Intel[®] Mobile Pentium[®] II Processor Specification Update

Release Date: December 2000

Order Number: 243887-027

The Mobile Pentium[®] II processor may contain design defects or errors known as errata which may cause the product to deviate from published specifications. Current characterized errata are documented in this Specification Update.

Old Mobile Pentium® II Processor in Mini-Cartridge Package Label with Supplier Matrix Mark

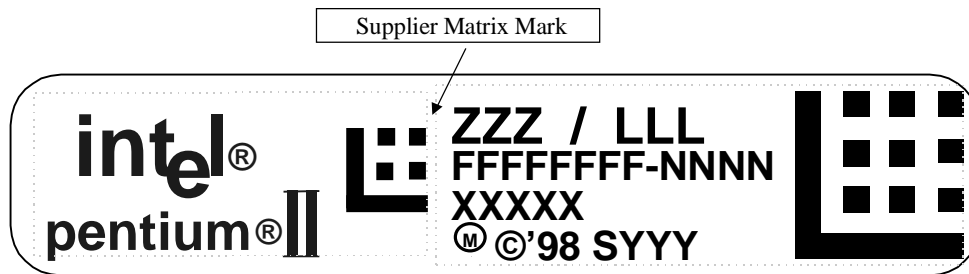
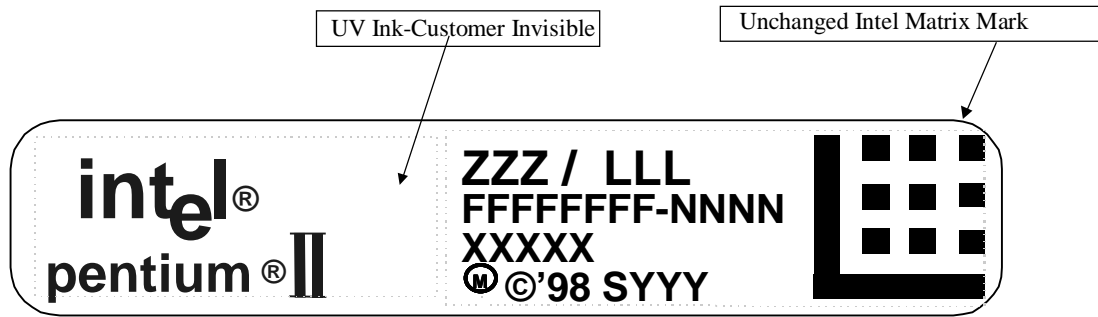
New Mobile Pentium® II Processor in Mini-Cartridge Package Label with Supplier Matrix Mark Removed

Figure 2. Workaround Flowchart: SMBALERT#-Driven System

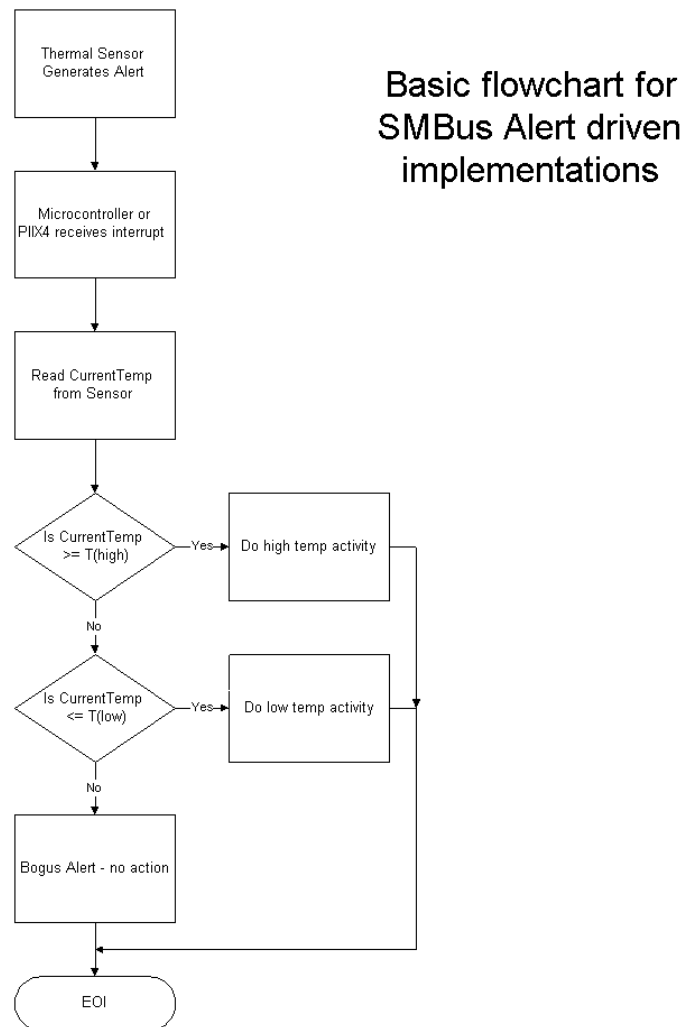
B30. Thermal Sensor May Assert SMBALERT# Incorrectly

Under the conditions described below, the thermal sensor incorrectly generates the SMBALERT# interrupt. All of the following conditions must be met to trigger a false interrupt:

1. Before servicing an interrupt from the thermal sensor, read and compare the processor thermal reading with the threshold limits (T_{HIGH} or T_{LOW}). Figures 2 and 3 provide basic flowcharts for the implementation of this workaround in an interrupt driven system.
2. If the firmware implemented polls the Status Register only, then before taking any action, re-read the temperature register and do a comparison with the alarm threshold limits (T_{HIGH} or T_{LOW}) to determine if the value is actually still within the temperature window.

3. Use a temperature polling scheme to monitor the processor temperature.

Figure 5.6. Cross Sectional View with Vertical Dimensions

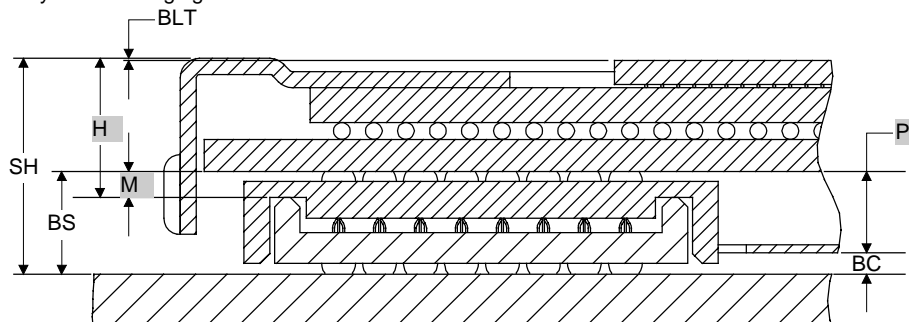
B1. Mislabeled Vertical Dimension Parameters

Figure 5.6 in the *Mobile Pentium® II Processor at 233 MHz, 266 MHz, and 300 MHz* datasheet should be replaced by the following figure:

Figure 5.3. Surface-Mount BGA1 Package—Top and Side View

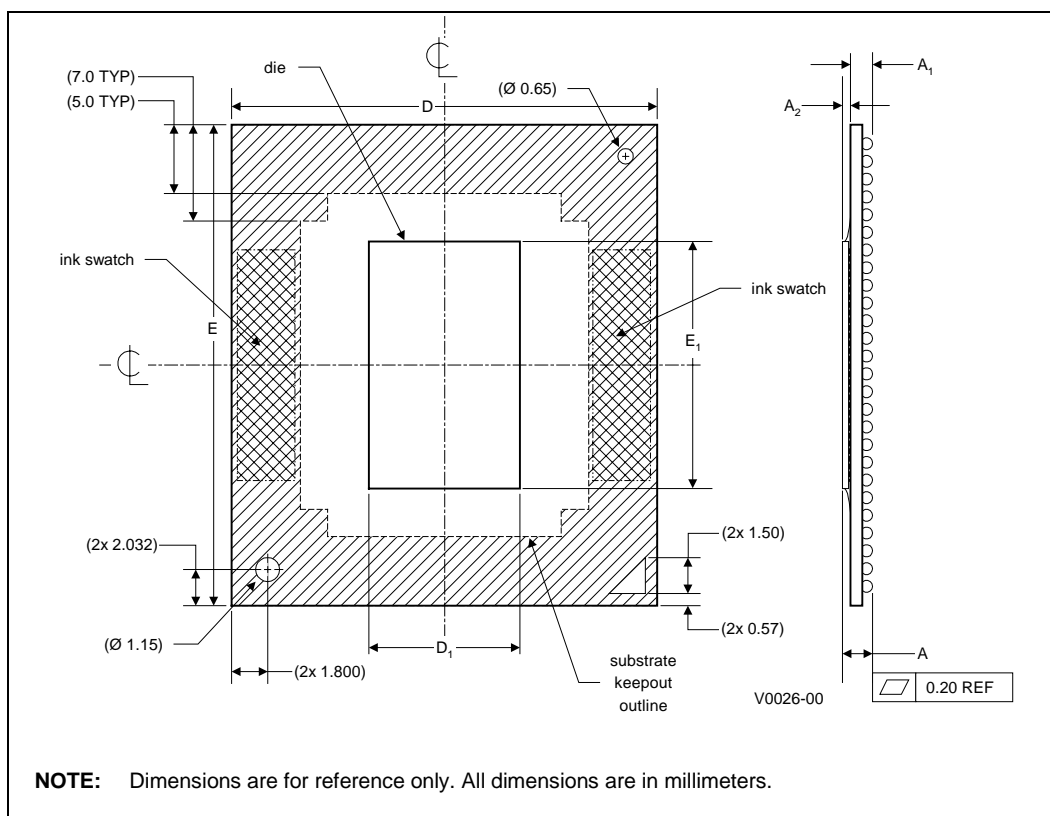
The following table and figures show the updated mechanical specifications for the BGA1 package, listed as Table 5.2, Figure 5.3 and Figure 5.4, respectively, in the *Mobile Pentium® II Processor in BGA Package at 366 MHz, 333 MHz, 300PE MHz, and 266PE MHz* datasheet.

Figure 3.3 Generic Clock Waveform

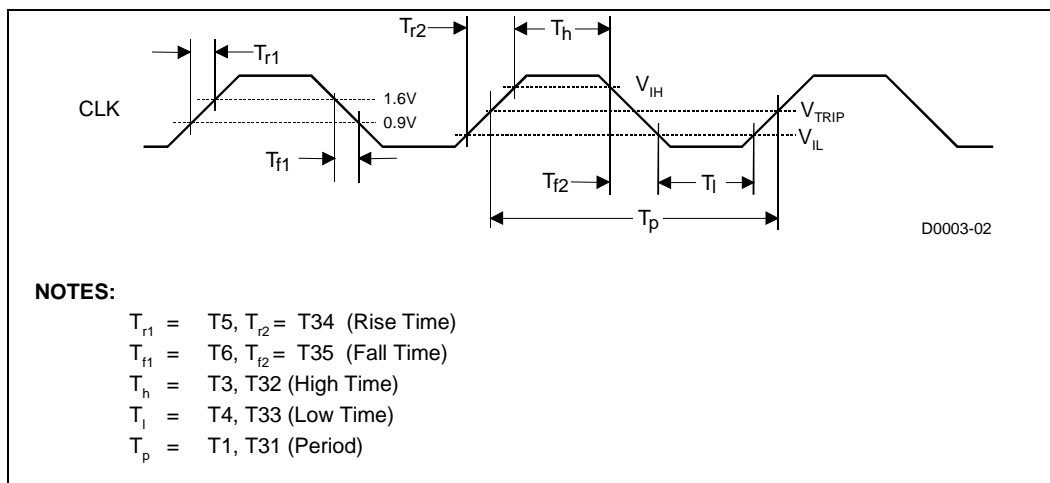
B14. Generic Clock Waveform Figure

Figure 3.3 in *Mobile Pentium® II Processor in Mini-Cartridge Package at 366 MHz, 333 MHz, 300PE MHz, and 266PE MHz* datasheet (Order Number 245108), and the *Mobile Pentium® II Processor in BGA Package at 366 MHz, 333 MHz, 300PE MHz, and 266PE MHz* datasheet (Order Number 245106) has been updated. The following figure is to replace the ones in the above documents.

Figure 1. TAP Gageable Thread Clarification

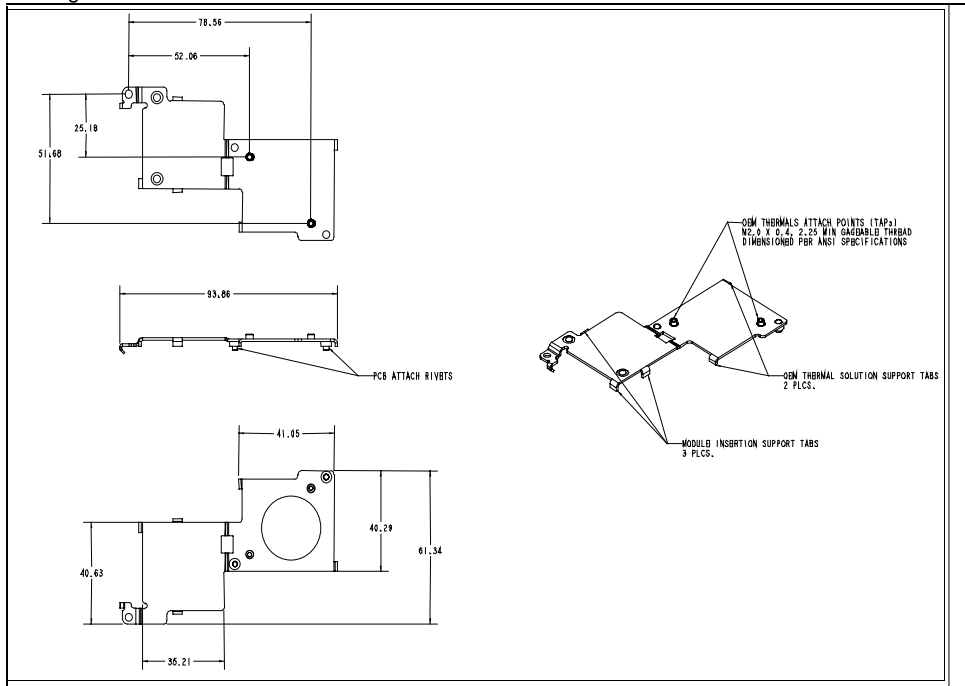
In the *Intel® Pentium® II Processor Mobile Module : Mobile Module Connector 1 (MMC-1)* and the *Intel® Pentium® II Processor Mobile Module : Mobile Module Connector 2 (MMC-2)* datasheets (Order Numbers 243667 and 243668, respectively), the thermal attach point (TAP) gageable thread specification was not clearly identified in Figure 14, of Section 5.2. The following is the TAP clarification:

OEM Thermal Attach Points (TAPs) M2.0 x 0.4, 2.25 min gageable thread dimensioned per ANSI specification.

See Figure 1 below for more information.
